Please be advised RKI Exploration requests approval to P&A the above well. The WBD and Plan are attached.

RDX 21-1H Plug and Abandon Procedure Stateline

Section 21 T-26S, R-30E
Eddy Co., New Mexico

API # 30-015-40849
Property # 154230

Proposed Plugged WBD

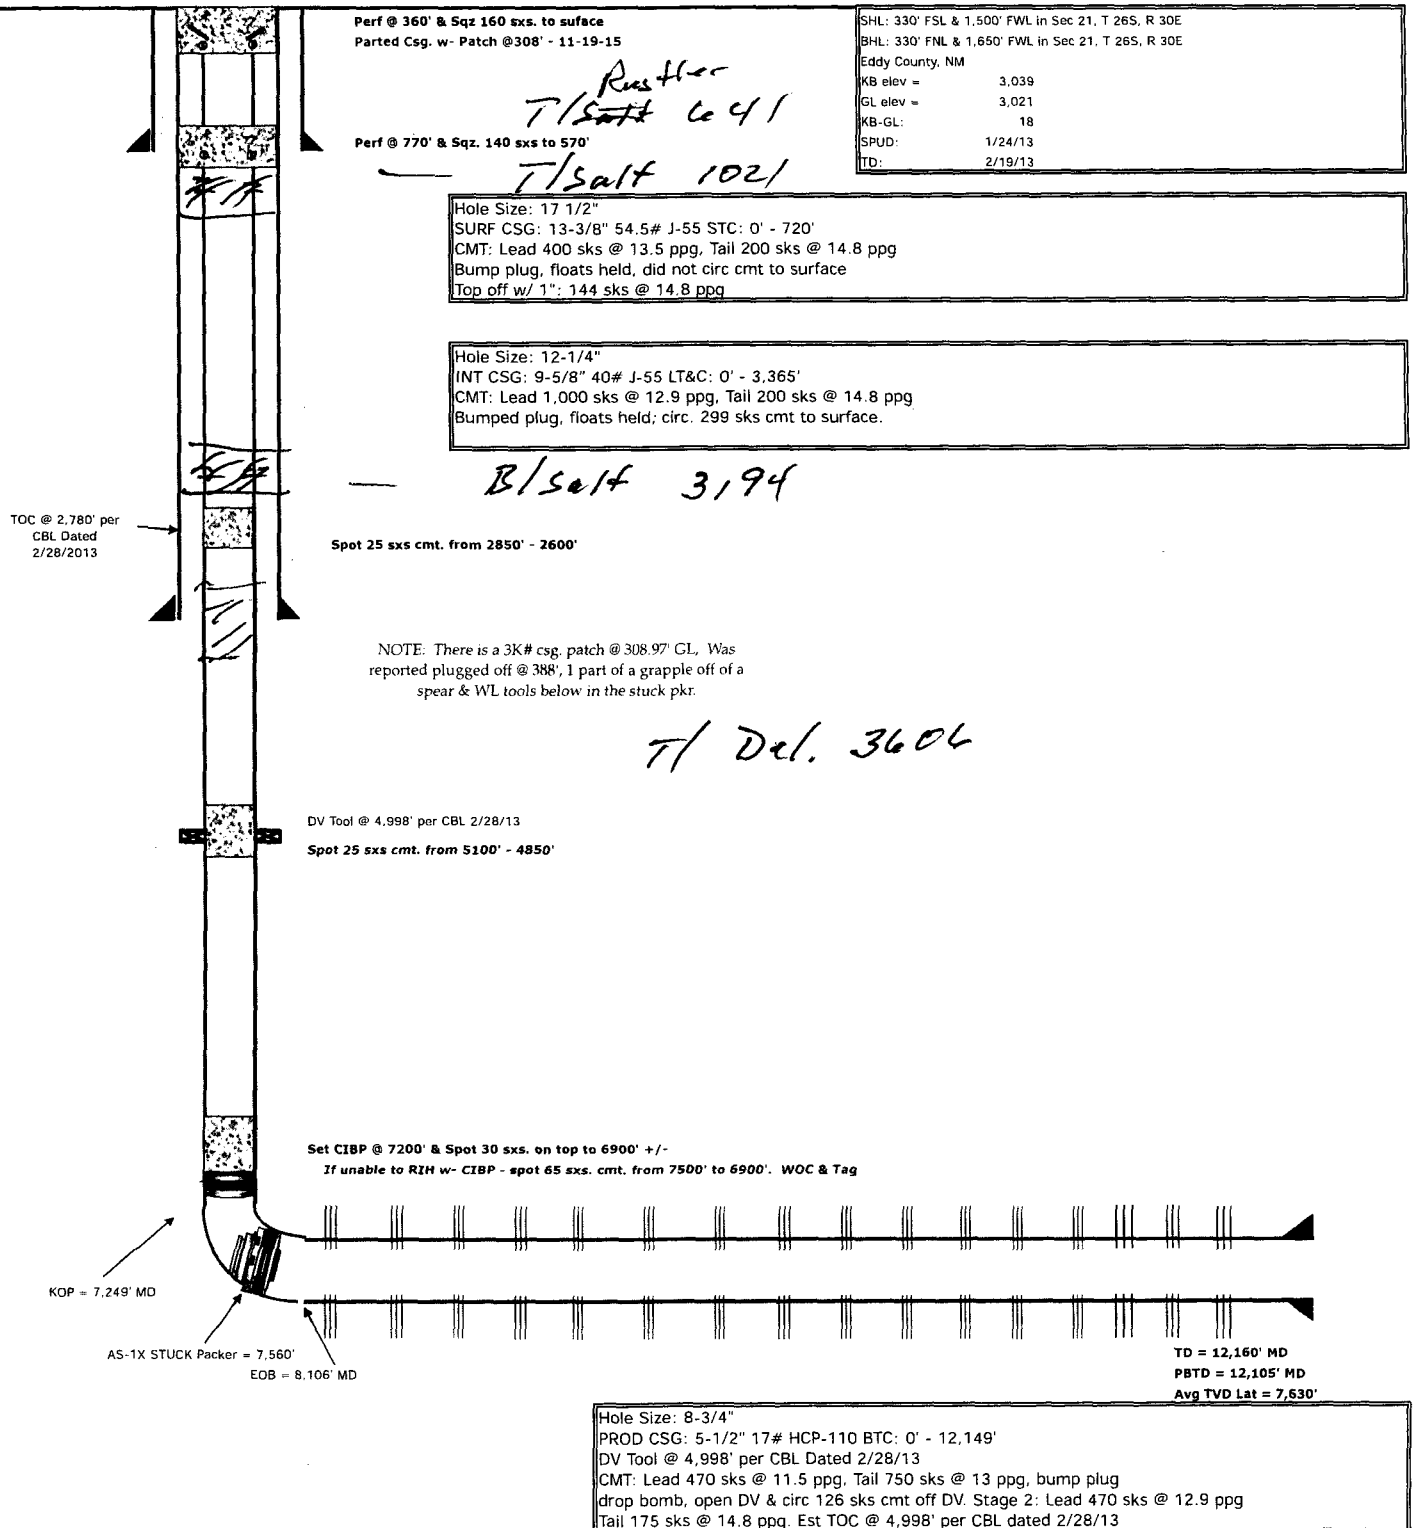
- 12) PU & LD tbg. to 2850'. Spot 25 sxs. from 2850' - 2600'. *Add Plug (25 sx min) From 3681 - 3551 (T/Delaware)*
Not Required
- 13) TOOH & stand back 500' in derrick & LD rest of tbg. *Add plug (25 sx min) From 3430 - 3300 (Shoe). WOC Tag*

- 14) RU WL - RIH & perf @ 770'. *Note can combine. Add plug (25 sx min) 3259 - 3129. WOC Tag. (B/salt) Note: can combine all 3.*
- 15) RIH w- Pkr & sqz. 140 sxs cmt. from 770' - 570'. *Perf Add Plug 1071 - 971 (T/salt, 25 sx min)*

- 16) WOC & Tag. *Can Combine*
- 17) RUWL - RIH & perf @ 360'.
- 18) RU pump & establish circulation & circulate 40 bbls. mud. Sqz. 160 sxs. cmt. from 360' to surface.
